MODIFICATIONS TO THE ACME 22.5-0.1 POWER SUPPLIES AND CURRENT READOUT LINES

B. Sandberg

May 1972

FIG 1 STEPPING MOTOR P.C BOARD MODIFICATIONS

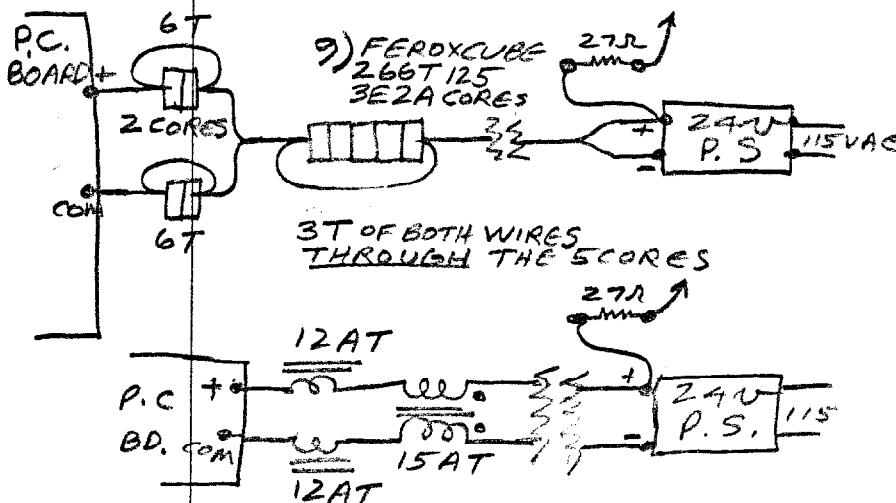
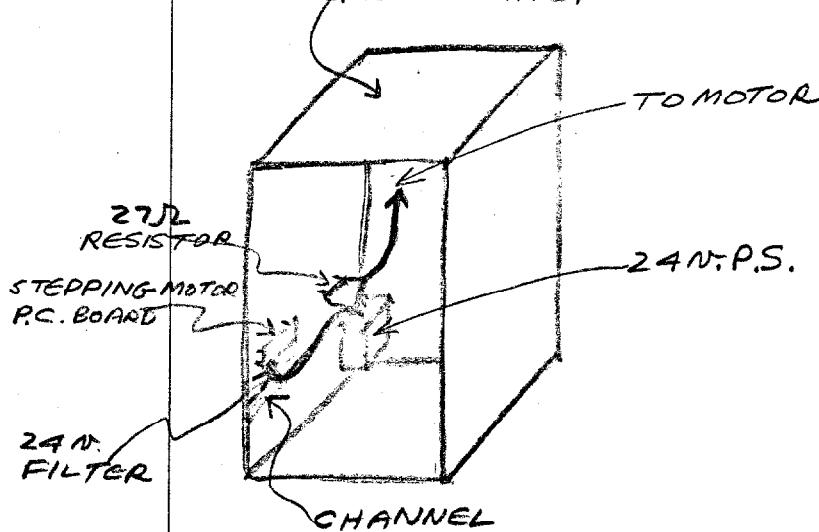
The solution of the stepping motor problem was simply to reposition and filter the 24-volt power to the stepping motor P.C. board. The object in this solution was to keep the 24-volt power leads to the P.C. board as short as possible and at the same time running them in the minimum noise environment. Figure 1 indicates the physical and electrical details of the solution.

- 1) MOUNT THE 24V P.S. WITH THE D.C. OUTPUT TERMINALS FACING UPWARD
- 2) MOUNT THE STEPPING MOTOR 2" ABOVE THE HORIZONTAL CHANNEL NEAR THE FRONT OF THE CABINET.
- 3) KEEP THE CABLE FROM THE 24V PS TO THE P.C. BOARD AGAINST THE CABINET WALL AND BELOW THE PC. BOARD.
- 4) MOUNT THE 27Ω, 11W RESISTOR NEAR AND ABOVE THE 24V P.S. (BE SURE TO USE 2) + 24V WIRES: ONE TO THE P.C. BOARD AND THE OTHER TO THE 27 Ω RESISTOR.).
- 5) INSTALL THE 24V FILTER AS NEAR TO THE P.C. BOARD AS POSSIBLE.

FIG. 2

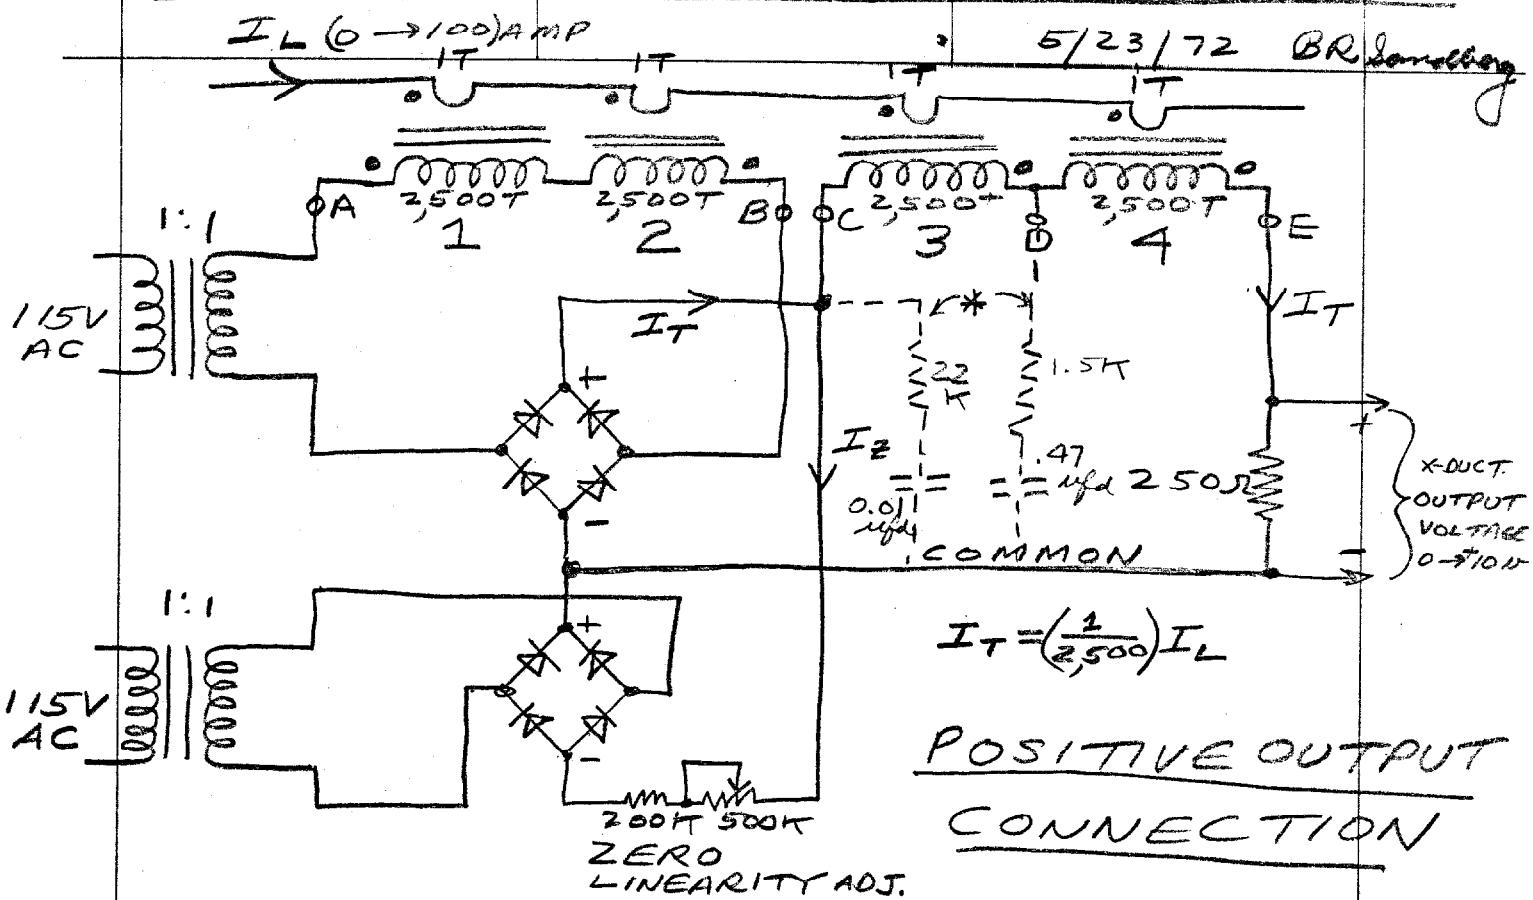
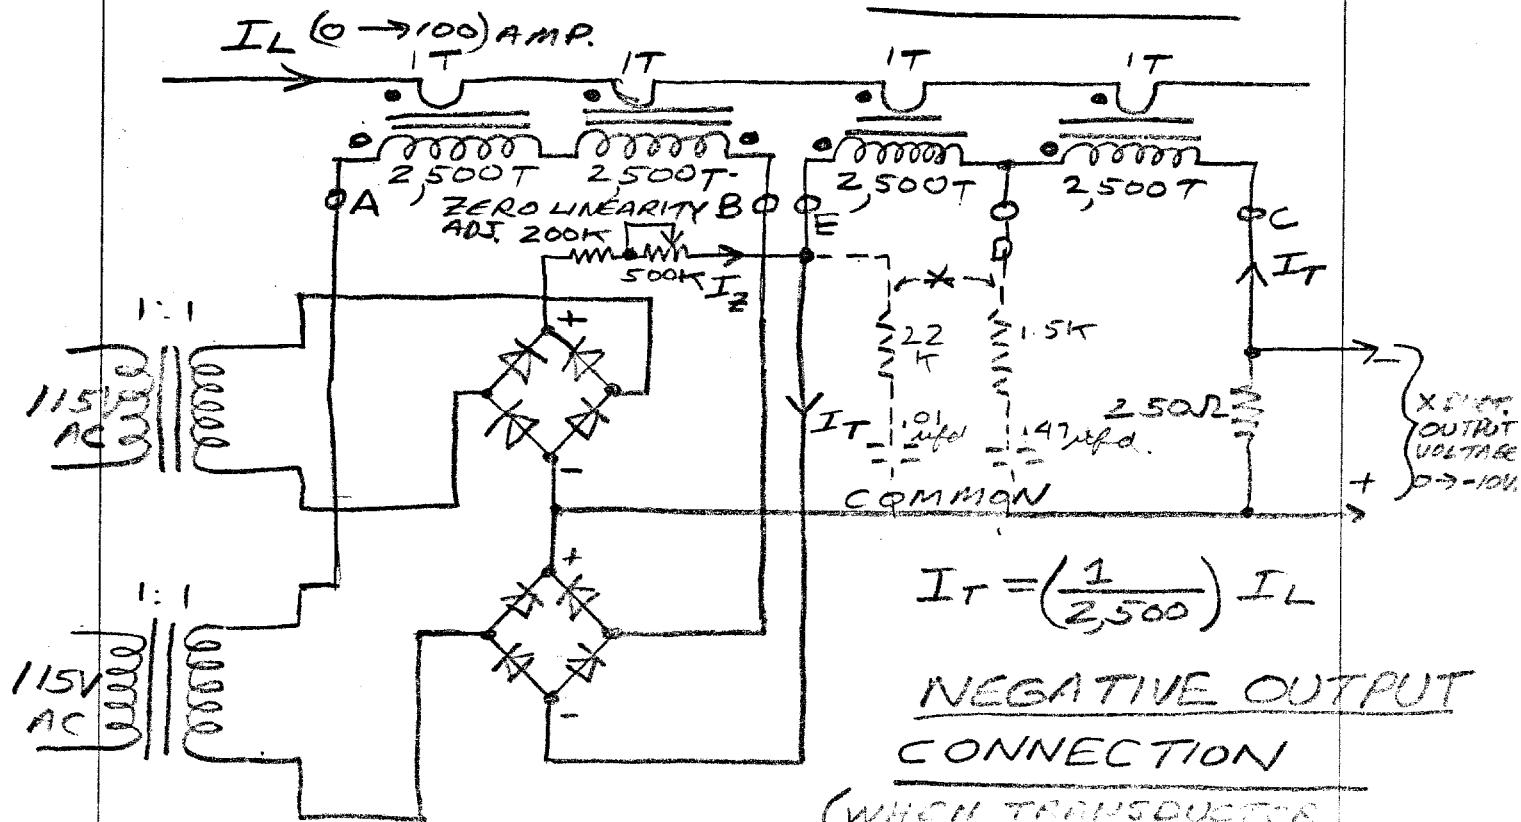
The transductor output signal was subdued by filtering at the point of entry to the CAMAC rack and further refined by correctly connecting its filtering coils. Figure 2 shows the correction connections for the transductor for both positive and negative output voltages. The ACME supply is designed with a negative transductor output and the actual transductor assembly is evidently installed for the more usual positive output. Therefore, to prevent coils 3 and 4 from saturating they must be reversed as indicated in Figure 2.

FIG 3 CAMAC FILTER FOR
TRANSDUCTOR OUTPUT

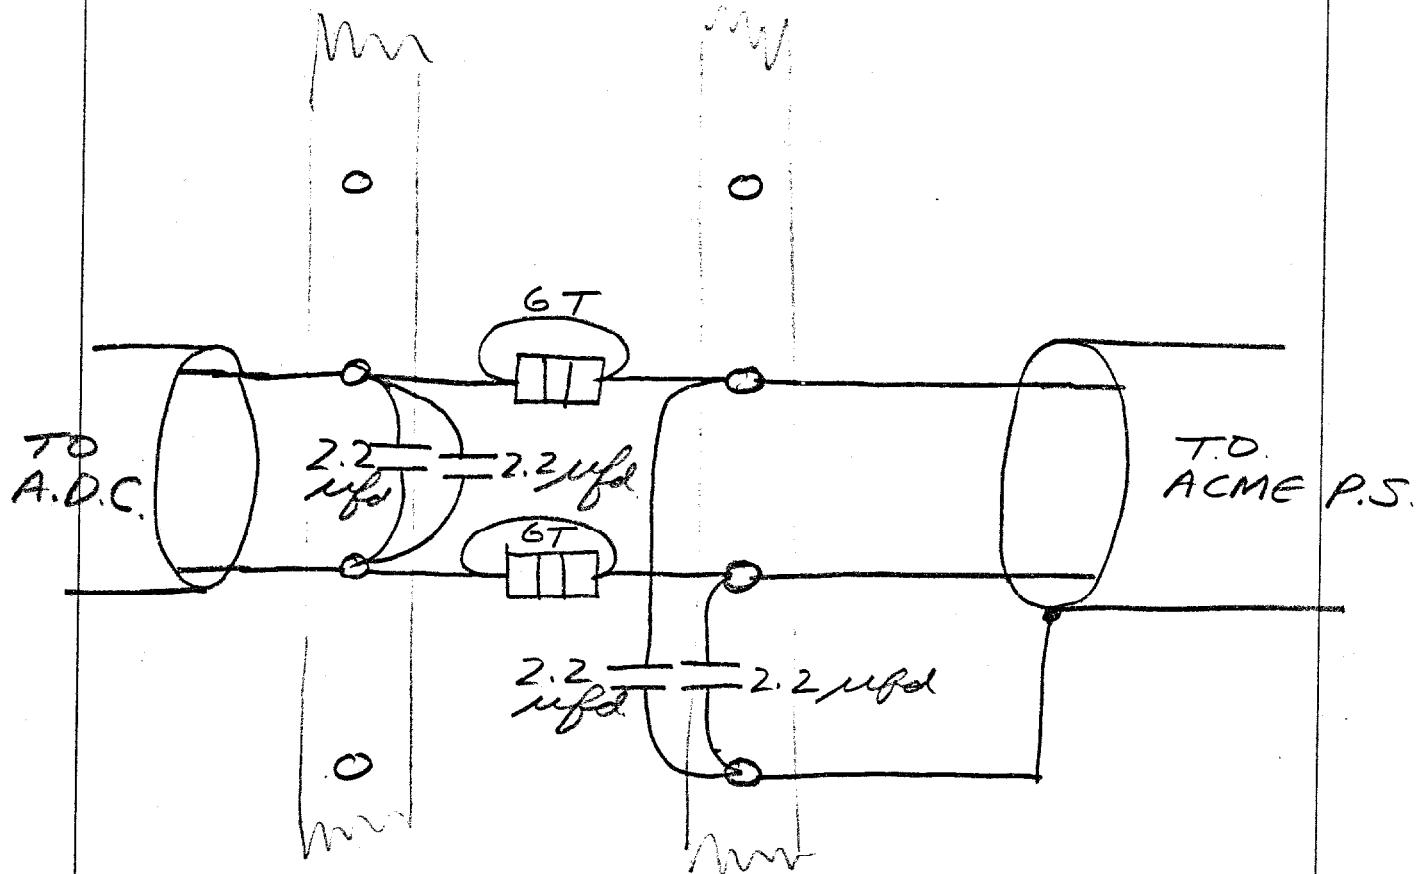
The CAMAC filter of the transductor output is indicated in Figure 3. It is conveniently installed as part of the jumpers that connect the power supply to the A.D.C. in the CAMAC rack.

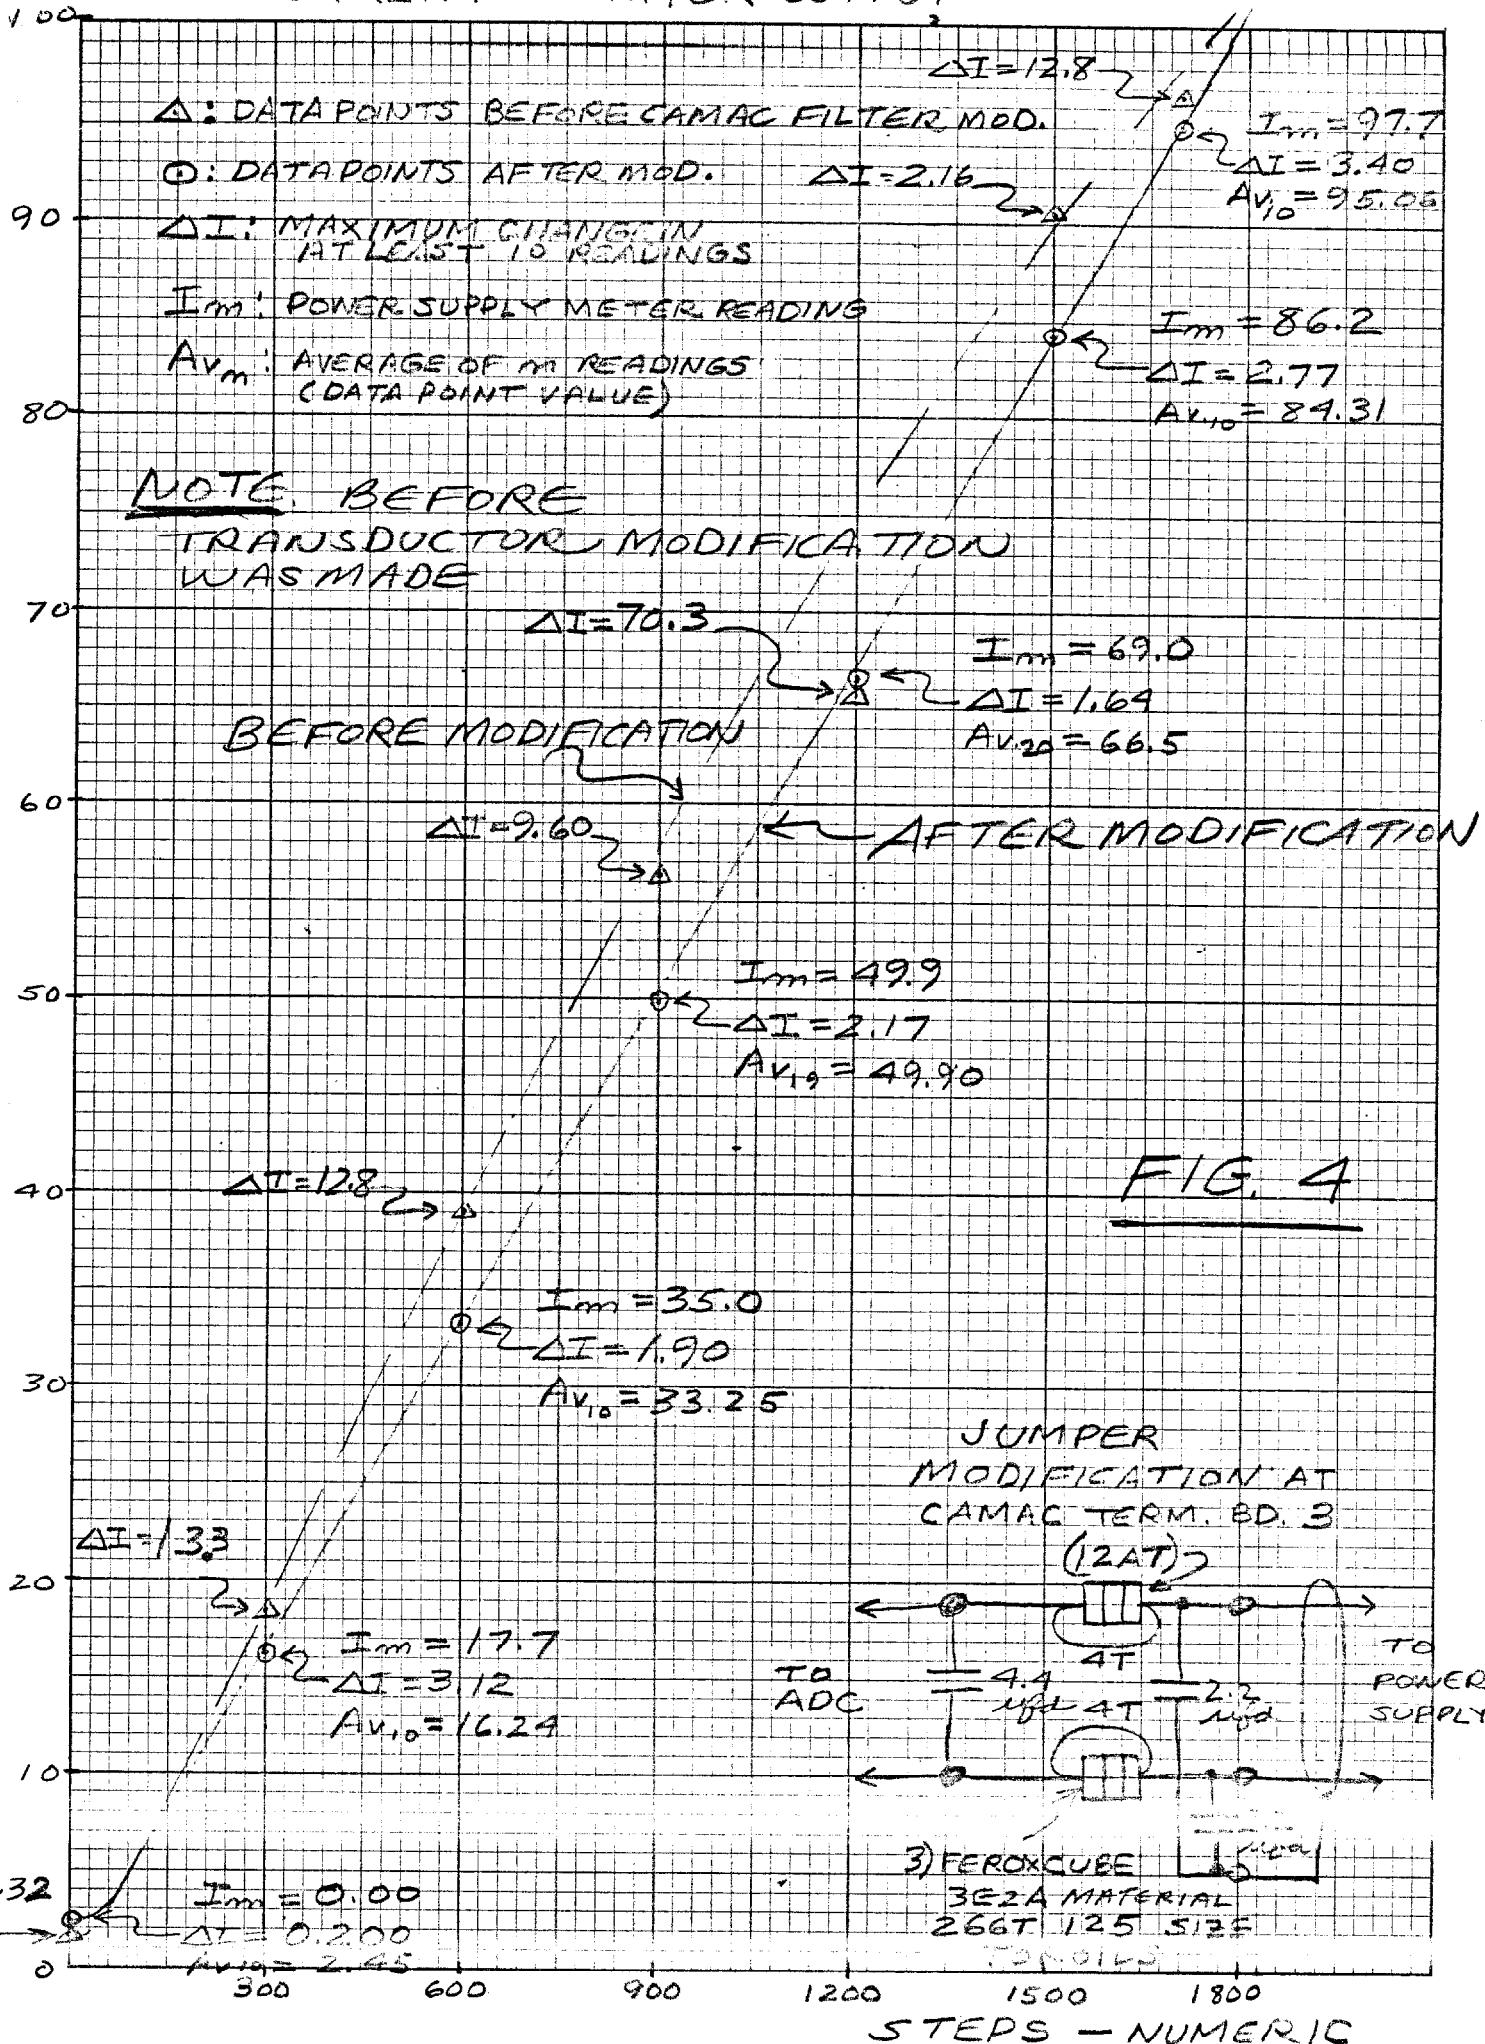
Since the ACME supply is operated in the static D.C. mode, further filtering would improve the transductor signal display if it is considered worth the effort. Presently the maximum variation in displayed signals is about 2 amps maximum. Figure 4 indicates the situation with only the CAMAC filter modification; and Table 1 shows the improvement achieved by first adding the CAMAC filter, and then correctly connecting the transductor, on the maximum range of display values.
